P 517992-A

A REPAIR A03198

ON-SITE SEWAGE DISPOSAL SYSTEM HOWARD COUNTY HEALTH DEPARTMENT BUREAU OF ENVIRONMENTAL HEALTH

SUBDIVISION: River Park Estates

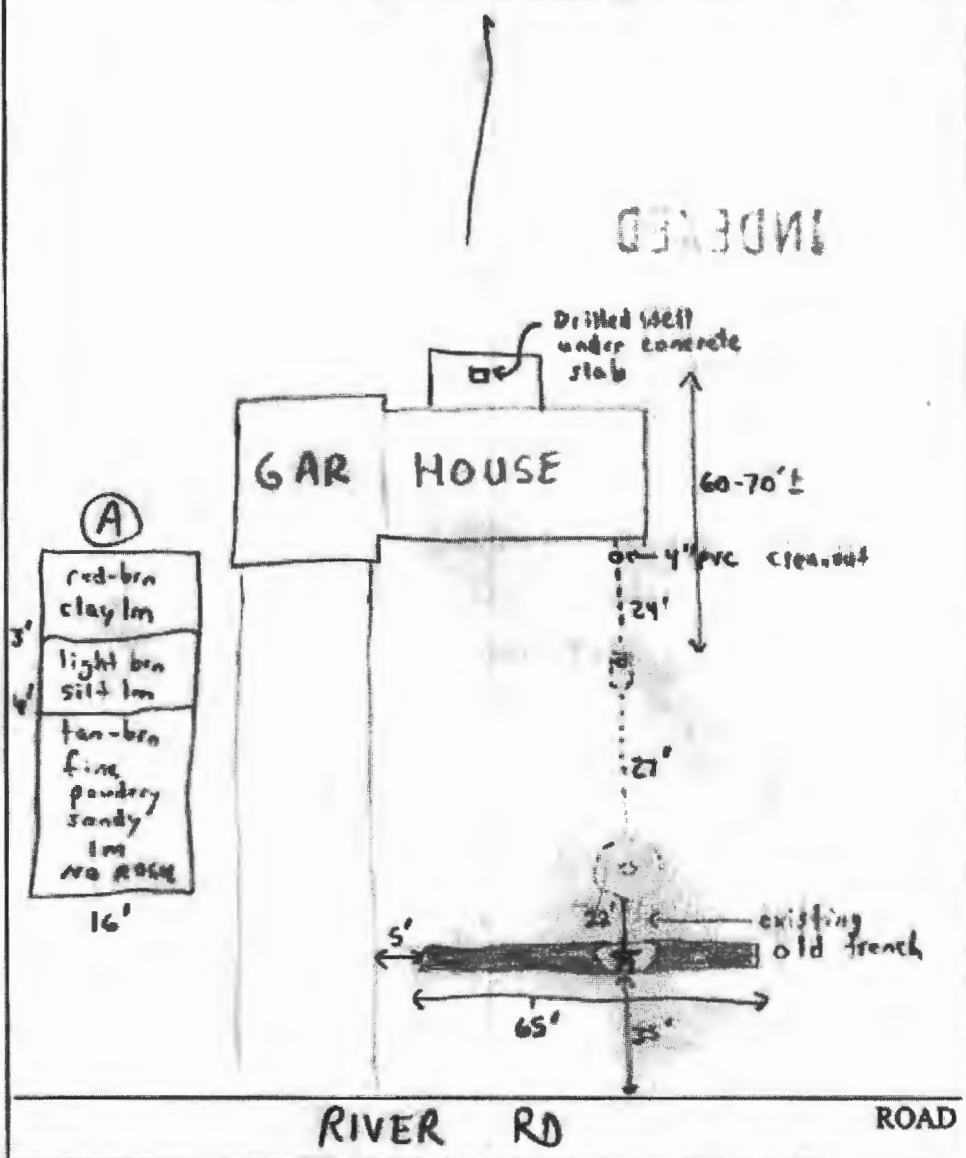
PRE-CONSTRUCTION 11/20/02 - MET CONTRACTOR (KENNY MAYNE) DUG PERC HOLE
 IN LOCATION (A) INSTALL AS DISCUSSED. A DRILLED WELL WAS OBSERVED
 INSTALLATION - 7100' SLIGHTLY DOWNSLOPE OF PROPOSED SEPTIC BUT NOT
 IN DIRECT DRAINAGE PATH OK (FA/SRK)
 INSTALLATION - 11/20/02 - OK TO COVER ALL WORK - (SRK)

1127 River Rd.
Lot 4
River Park Estates
Lot 4, Parcel 97, Sect I

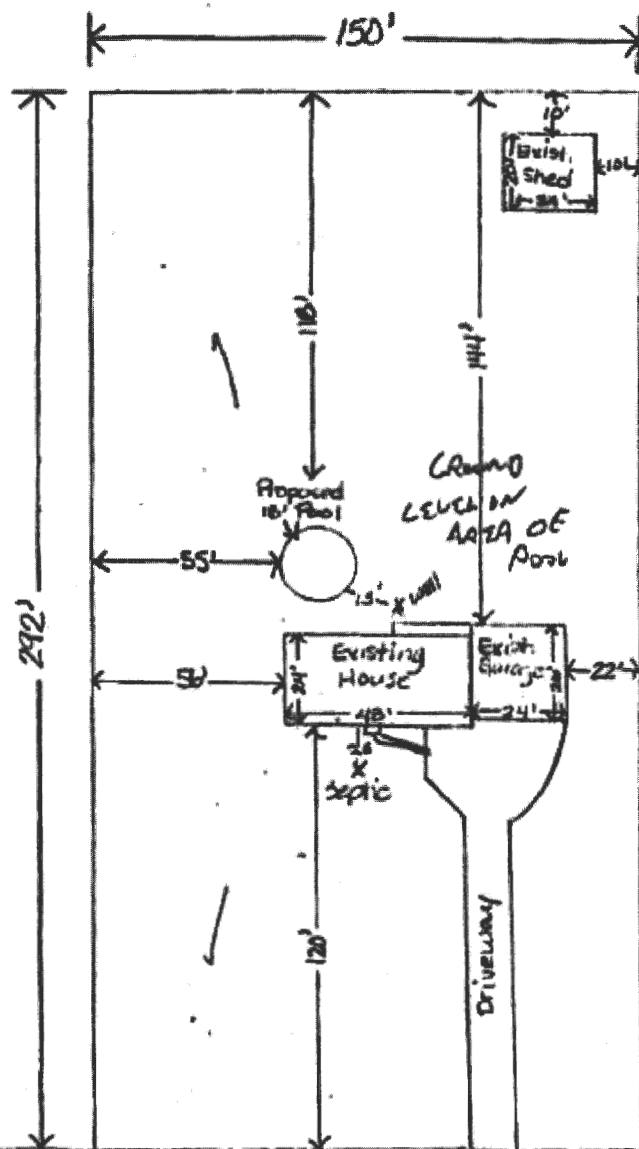
ONE SEPTIC CLEANOUT IS UNDER YARD ORNAMENT IN FRONT OF HOUSE

WELL IS CLOSER - OWNER SAYS NO PIT, 1' FROM HOUSE, 7' FROM PORCH

PROPOSED POOL IS NO CLOSER TO WELL THAN EXISTING HOUSE SCORRATH OK TO ACCESS
